Published by:  
Service Department Audio

# SERVICE NEWSLETTER

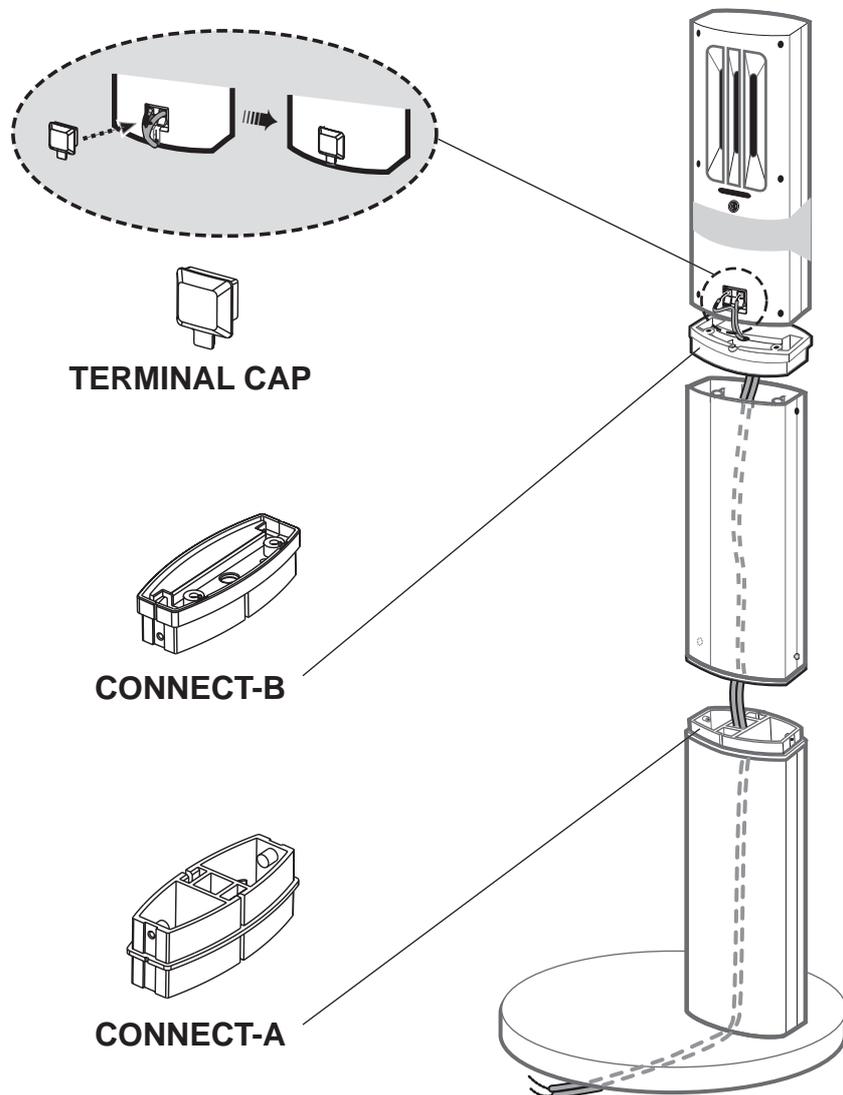
**INFORMATION** : In course of production a pole has been added to the Bottom Cabinet to strengthen the pcb supporting. If an old Bottom Cabinet needs to be replaced by a new one, we suggest to cut the pole as indicated in the drawing below:

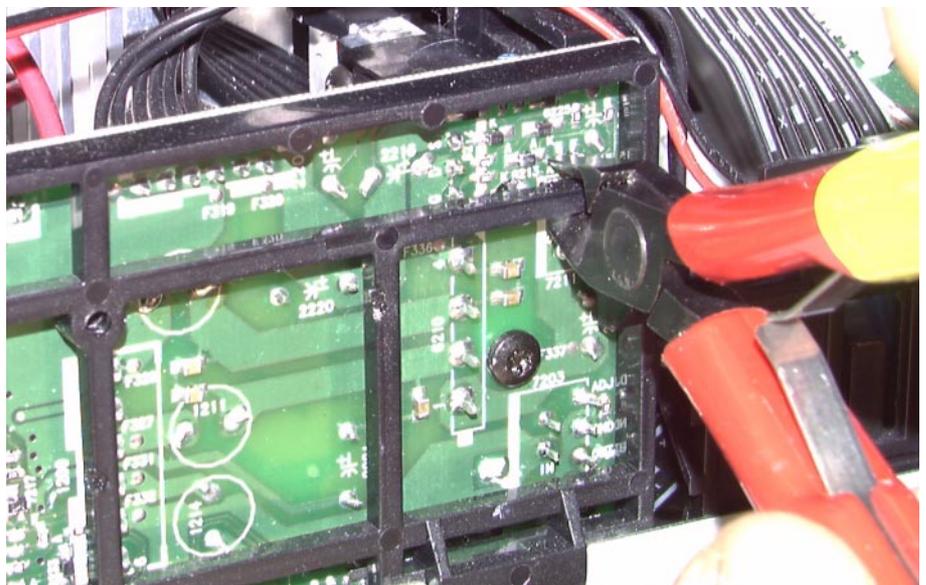
New AVC board (3139 113 35181) with extra muting circuit and new software version “30” (new mask µP 12NC: 3139 110 53571) will be introduced to solve the acoustic feedback problem without removing the two resistors.

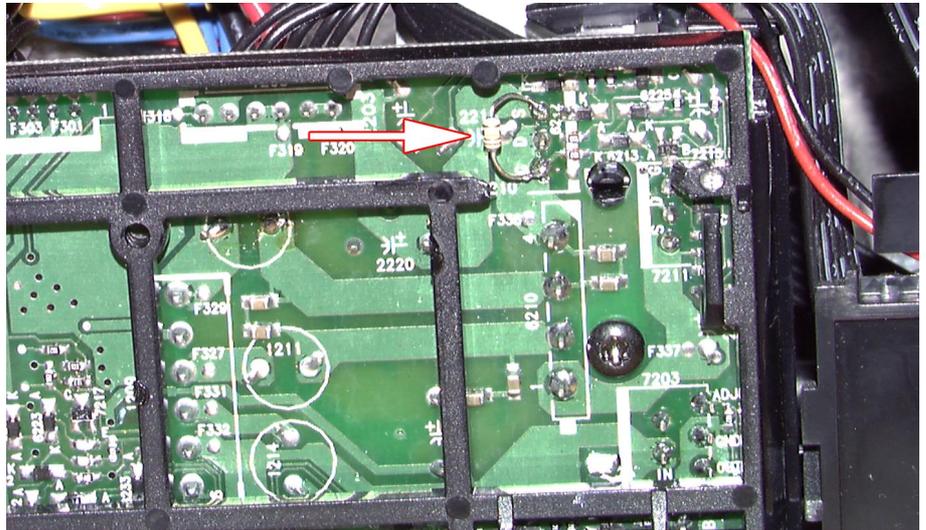
1. Cut off rib of frame to get proper access to FET 7210

## 2. Solder 100kΩ resistor between Gate and Source of FET 7210

old Power board

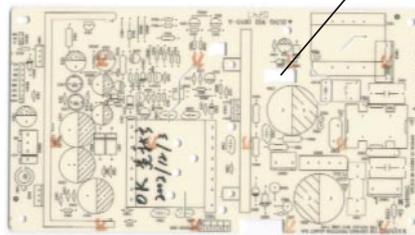
After 10...30 minutes of operation the set shuts down to standby mode.

CURE : The phenomenon is caused by a thermal problem. Due to poor ventilation IC903 becomes too hot. Heat ventilation has been improved by adding hole(s) on Power board versions C and higher. For repairs replace the complete Power board with an improved one – codenumber 9665 000 18105.

improved Power board ver. C

hole(s) added  
(Transformer is removed for clearer view)

Figure 1

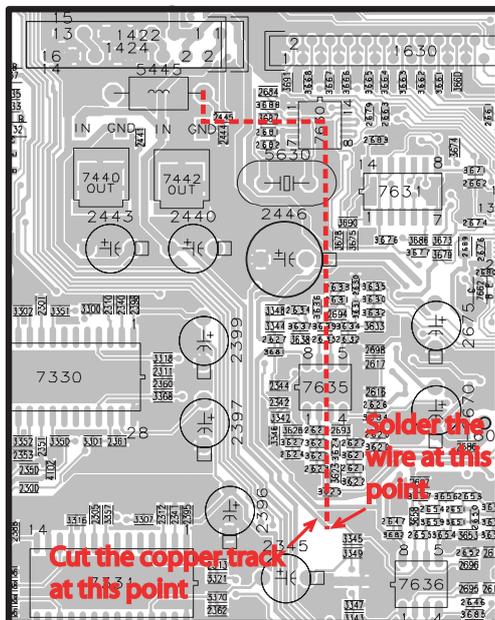
**CURE :**

1. Cut the +5V6 supply to resistor 3470.
2. Connect a wire from resistor 3470 to coil 5445 (+5V\_DVD on Schematic diagram).
3. See figure 1..4 for details.
